**ADDRESS: 8330 MILLMAN ST**

Proposal: Construct building for accessory dwelling unit

Review Requested: In-Concept Approval

# VANNA VENTURI HOUSE: ACCESSORY DWELLING UNIT THE GARDEN PAVILION

**Figure 1:** 2020 aerial showing 8330 Millman Street. Source: Atlas.

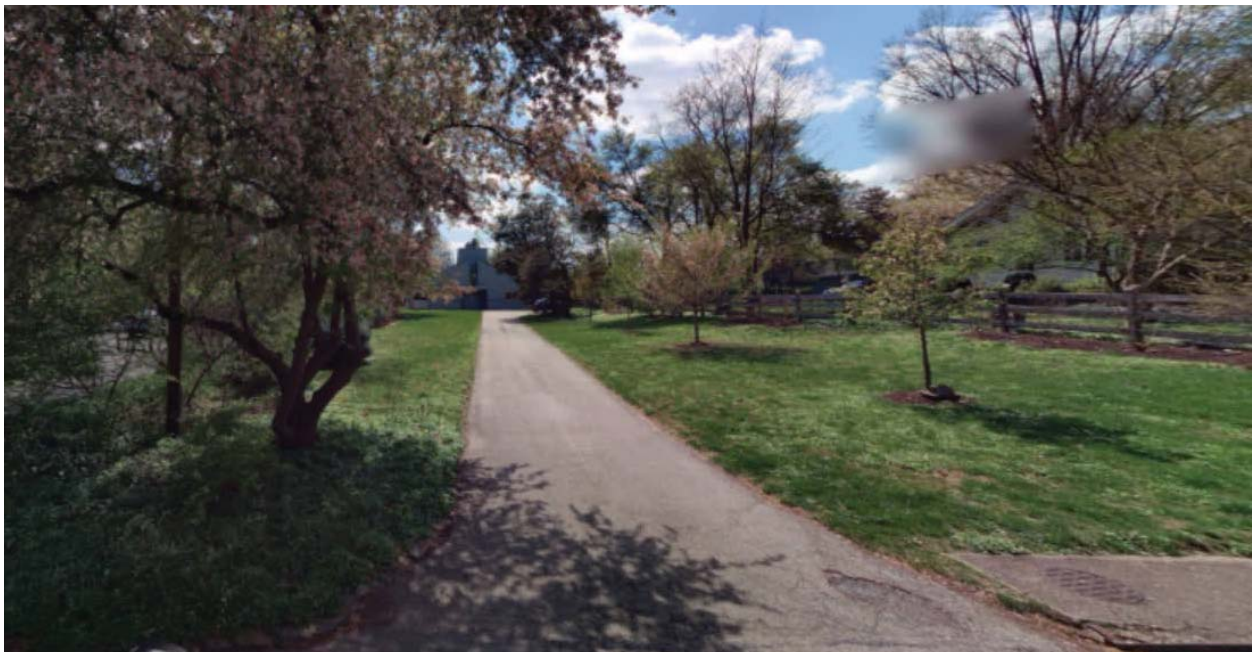
- The proposed one-story building would be differentiated from the historic building and would be compatible in massing, size, scale, and architectural features.

- The proposed building's location on the site would have minimal impact on the historic integrity of the property and its environment.
- Guidelines for New Exterior Additions to Historic Buildings and Related New Construction:

- *Not Recommended: Adding new construction that results in the diminution or loss of the historic character of the building, including its design, materials, location, or setting.*
- o The new building would be located behind the neighboring property at 8336 Millman Street and would have minimal visibility from the public right-of-way; it would, therefore, not obstruct views of the Vanna Venturi House. The proposed building would be located on the site of a non-historic shed, behind the current parking area.
- o Owing to the massing, size, and scale of the new construction and its siting 37'-6" from the historic building, the new construction would not result in the diminution of the historic character of the Vanna Venturi House.

**STAFF RECOMMENDATION:** Approval, pursuant to Standard 9 and the Guidelines for New Exterior Additions to Historic Buildings and Related New Construction, and the Historical Commission's 10 December 2021 approval of an in-concept application.

## APPROACH: The Courtyard

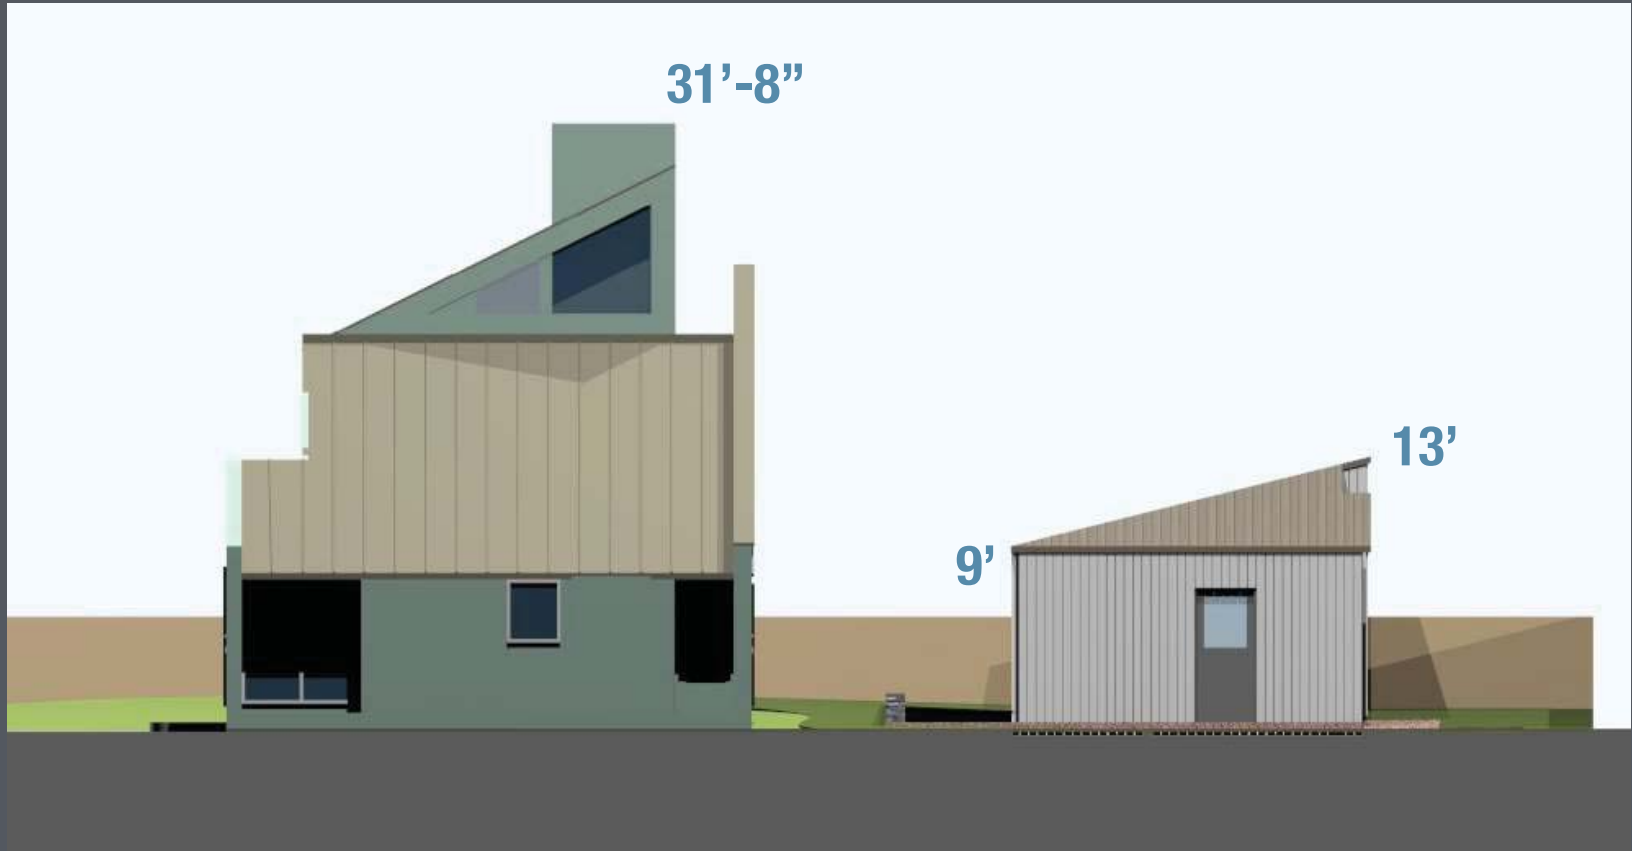
The courtyard is a significant architectural feature and very important to the owner...

1. The courtyard was decreased by a little over a foot. The width of that is as small as it can be in order to maintain a separate kitchenette that needs to be far away and apart from the piano (humidity damages pianos). The counterspace was reduced to as small as would be desirable.

2. The courtyard 'breaks up' the mass of the ADU and integrates the garden into the design. It is the main exterior design feature that the ADU is based upon.

3. Creating just one singular solid mass actually creates more of a 'heavy' and massive structure when looking at the overall building within the organic landscape.

4. When completely eliminated, only 4 additional feet are gained in separation which is not worth losing all the advantages of the courtyard. (The width of the ADU would be 44'-5" without the courtyard and is currently 48'-8" with the shrunken courtyard.)

5. With all of the foliage and density of trees separating the VV House and the ADU, the lack of its visibility is the same whether or not there is a courtyard.

6. The client strongly desires to keep the courtyard so that while inside, the views from the interior to the garden make the ADU feel like it is part of the property. The garden has been a hobby and integral part of owning the VV House.
